Addendum No. 1 dated 17 July 2018

**Pre-bid Meeting Minutes – Addendum No 1**

**ITB-PAL-0000049343 - Construction of New Small-Scale Desalination Units For Educational Facilities**

1-Al Shoka School

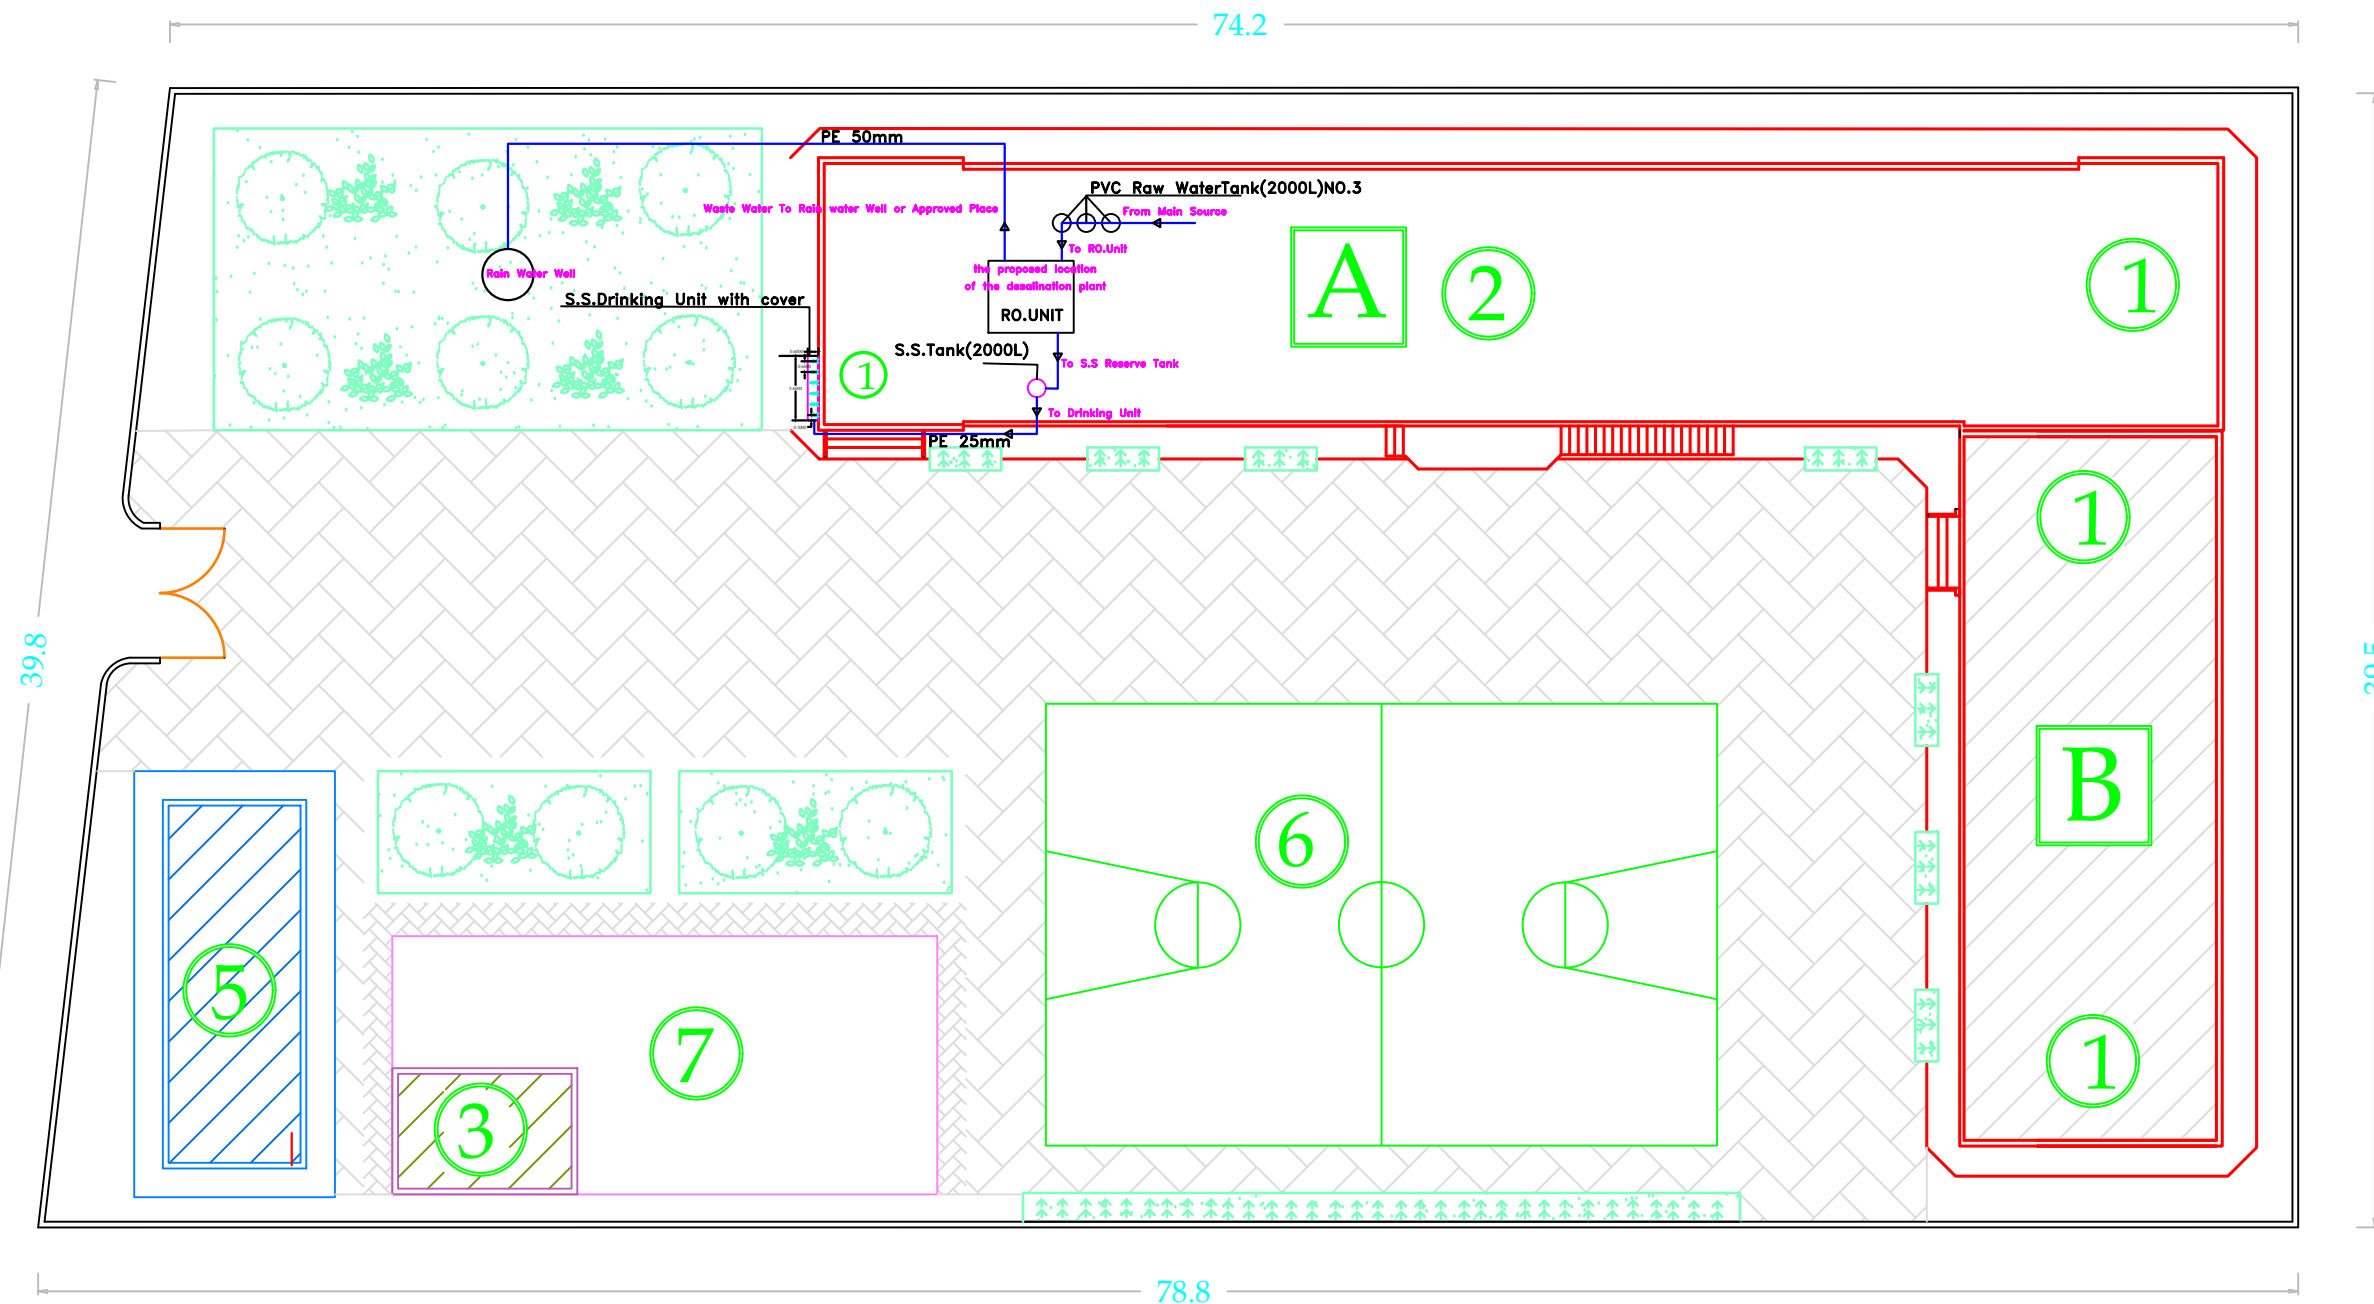
42. For Al Shoka School, Abasan School and Bani Sohila School, the work will be implemented (as shown in the attached revised drawings ). Item 1.01 price include supply and install 3 PVC Raw water tanks 2.0 m3 capacity with all needed connections, fittings, valves and all other needed parts .

LOT# 2 1-Al Alazhar Uni.-Scientific Colleges  
2-Al Alazhar Uni.-Colleges of Literature  
3-Al Esraa Uni.  
4-UCAS Uni.

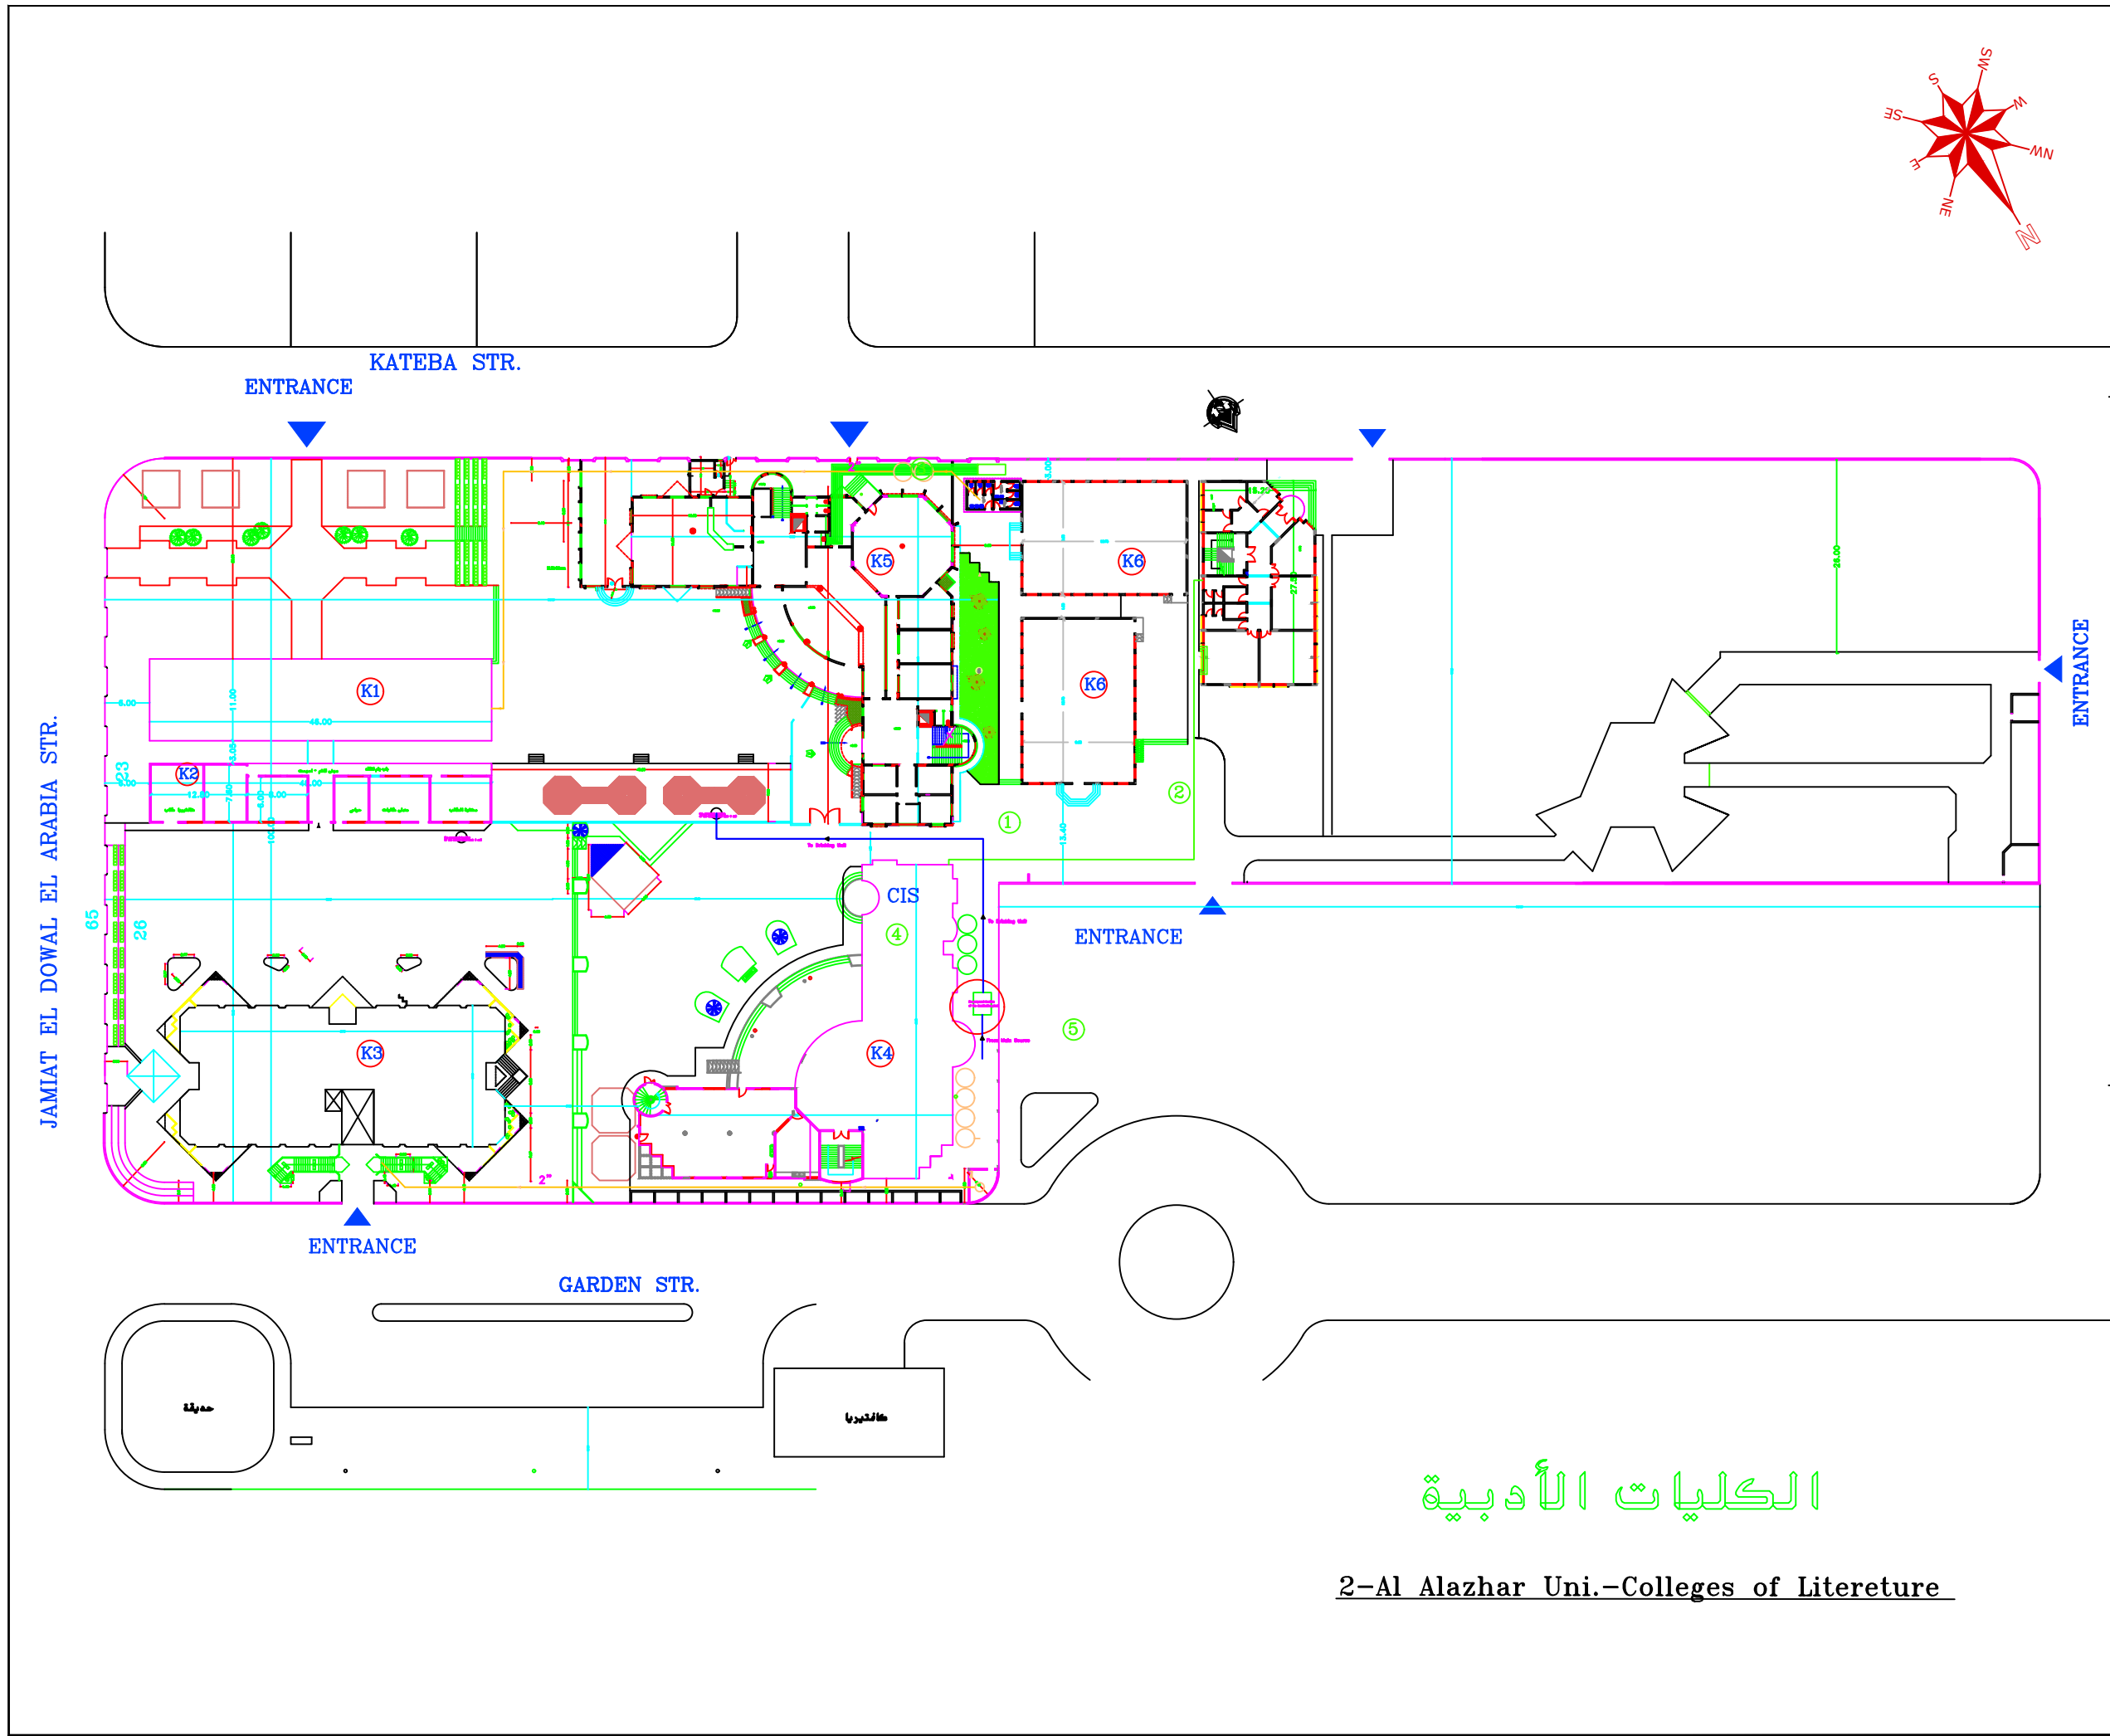
52. For Al Azhar University Colleges of literature- The work includes supply the desalinated water to drinking tank placing next to Jawwal stall at shed area form desalination unit (as shown attached revised drawings), the price includes all needed water pump, control cable to complete work correctly.

54. Attached revised drawing for Al Alazhar University-Colleges of Literature
55. **The original Bill of quantities is hereby replaced by a revised version, attached to this addendum. Interested bidders are there required to dully fill in/ price and submit the revised version of the BOQ along with their bids. In case any bidders use and submits the unrevised/original version of the bill of quantities, this shall cause UNDP to reject his bid as unresponsive. In case the bidder submits both versions of the BOQ, then UNDP shall consider only the revised BOQ version when evaluation his bid.**
